September 30, 2020

# Subject:Former GE Farrell Road, NYSDEC Site No. 734055Response to Submittal of Draft Building #2 Remedial System Optimization Study

On behalf of Lockheed Martin Corporation (Lockheed Martin), AECOM Technical Services, Inc. (AECOM) has addressed comments received from the New York State Department of Environmental Conservation (NYSDEC) dated July 27, 2020 regarding the draft submittal of the Building #2 Remedial System Optimization (RSO) Study.

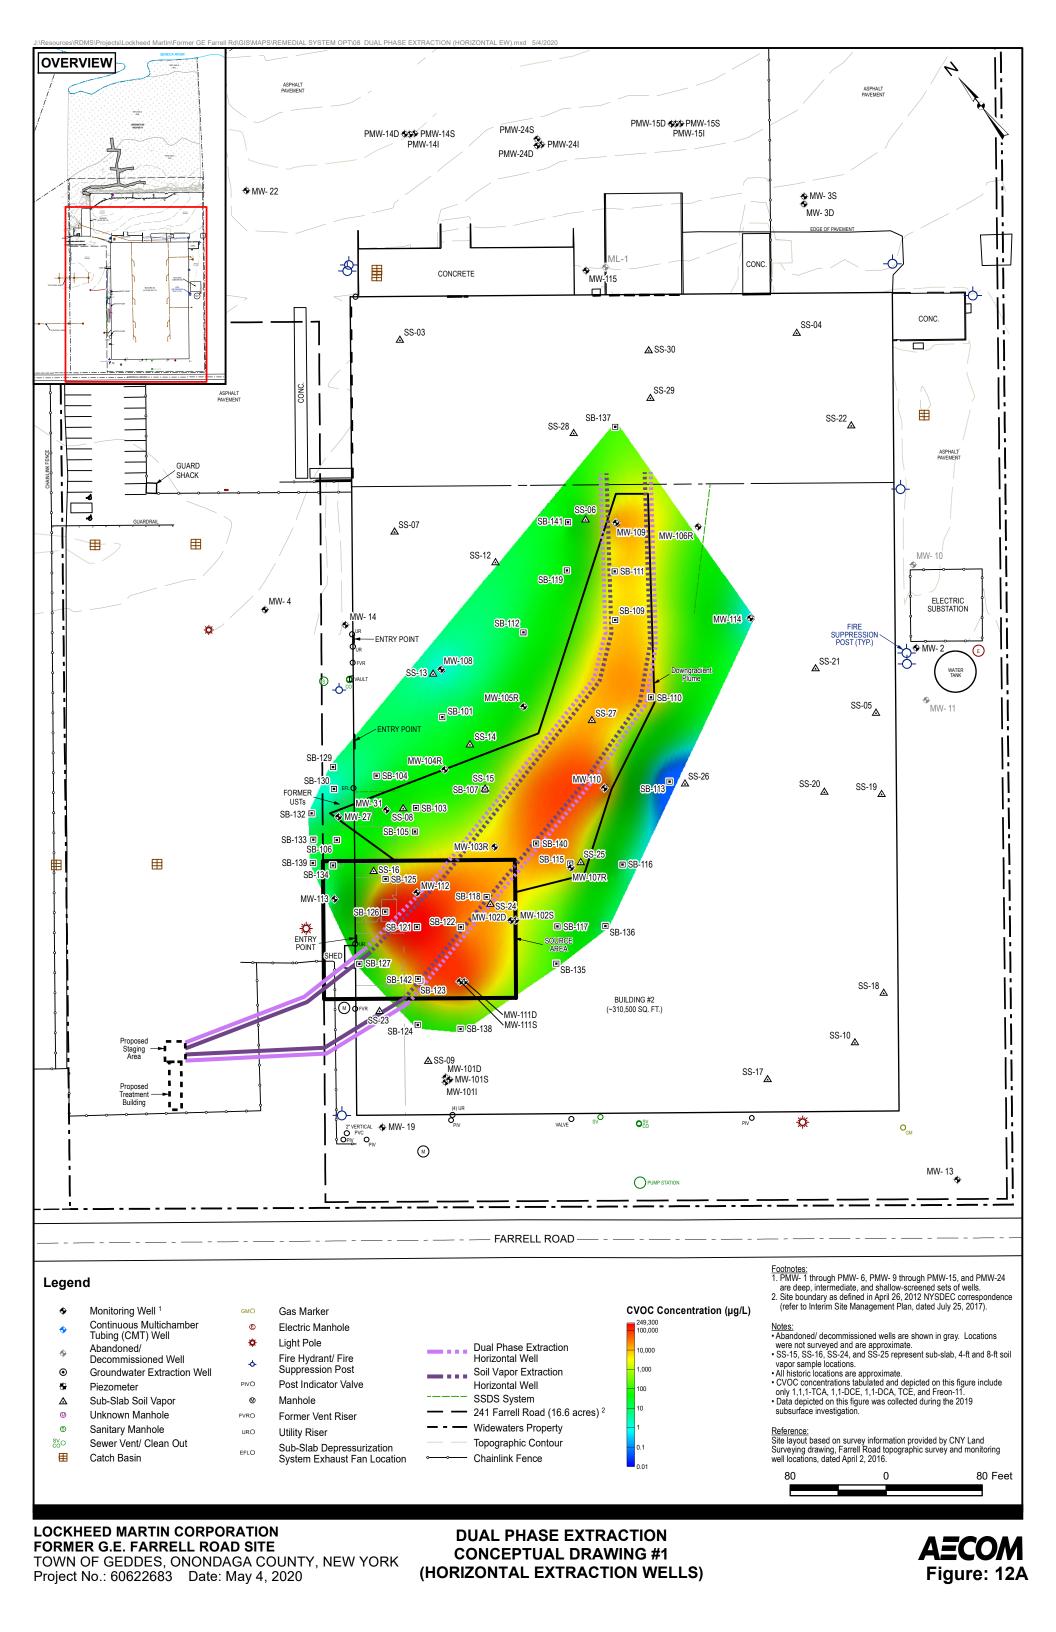
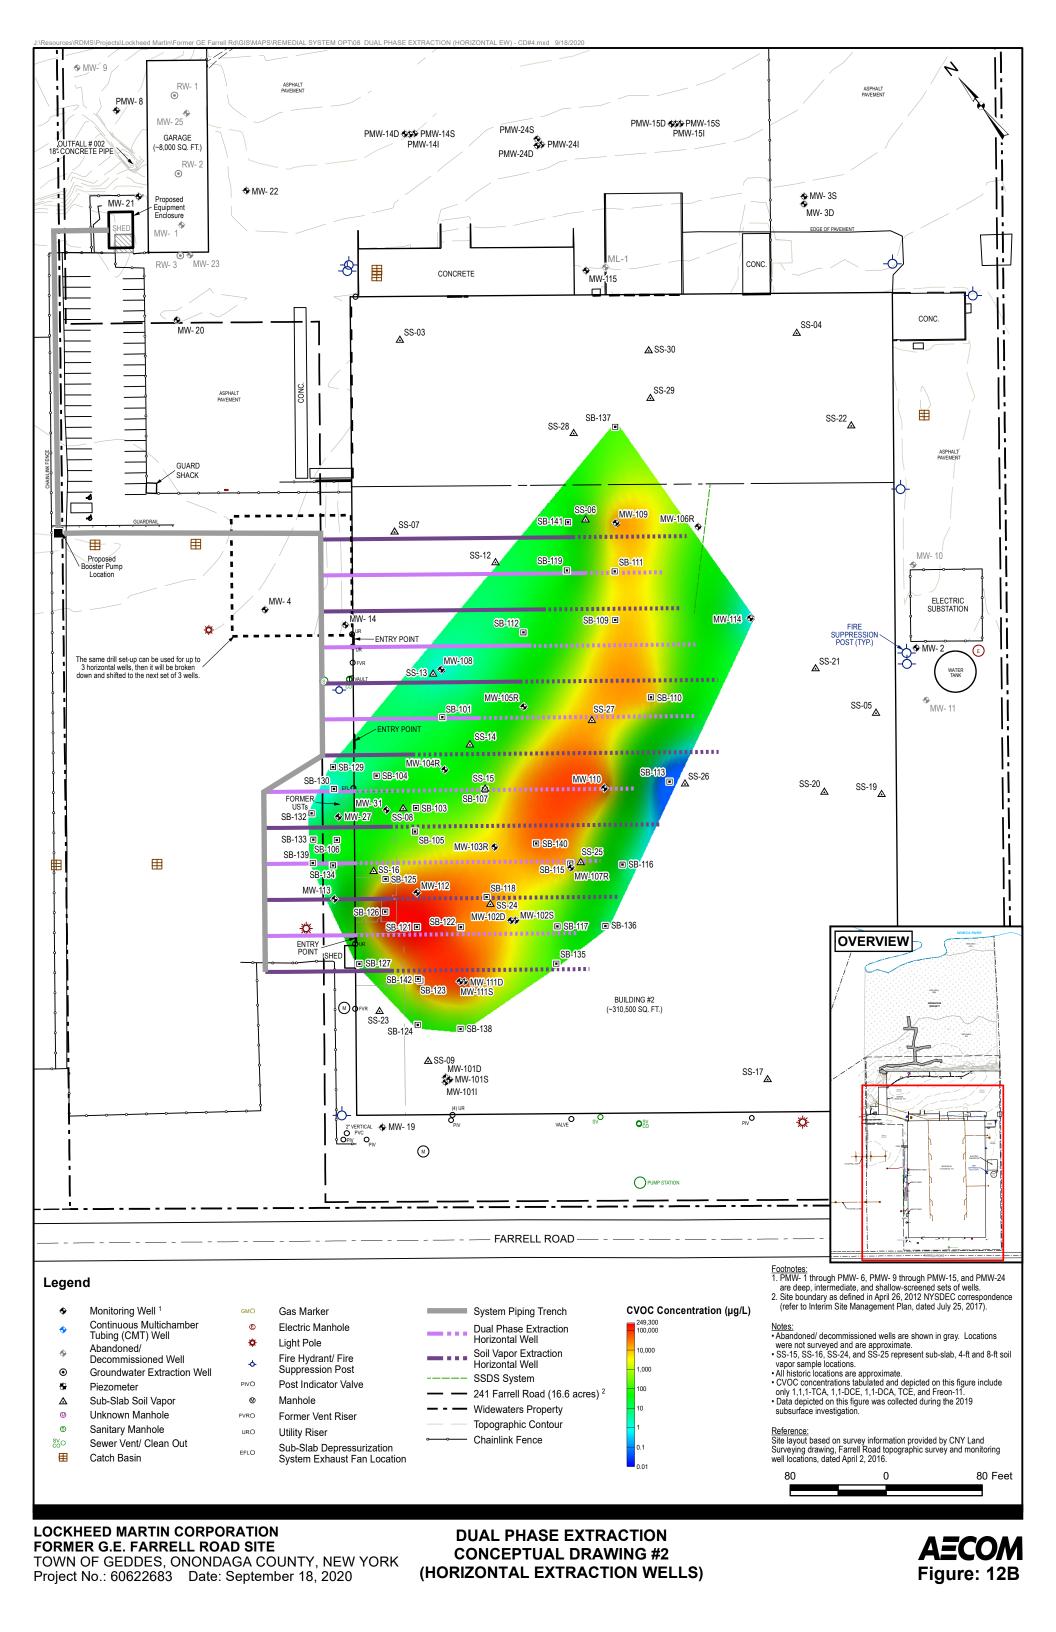
28. Figure 12 – Include the location of known utilities (including the SSDS) and evaluate whether it would be possible to install the horizontal wells as shown, including if temporary or permanent relocation of some utilities might be necessary and/or a realignment of the proposed path, or if the DPE wells would be deep enough so as to not conflict with the known utilities.

The conceptual drawings that are provided in the RSO Study provide the general layout of each proposed technology. In consideration of DPE being the recommended technology, additional narrative has been included Section 6.2.6 to expand on the flexibility the design offers to adjust for utilities and/or property developments. Should DPE move forward as the optimized remedial approach, the detailed engineering design will address locations of utilities and provide cross-sectional drawings that show the locations of the horizontal well installations.
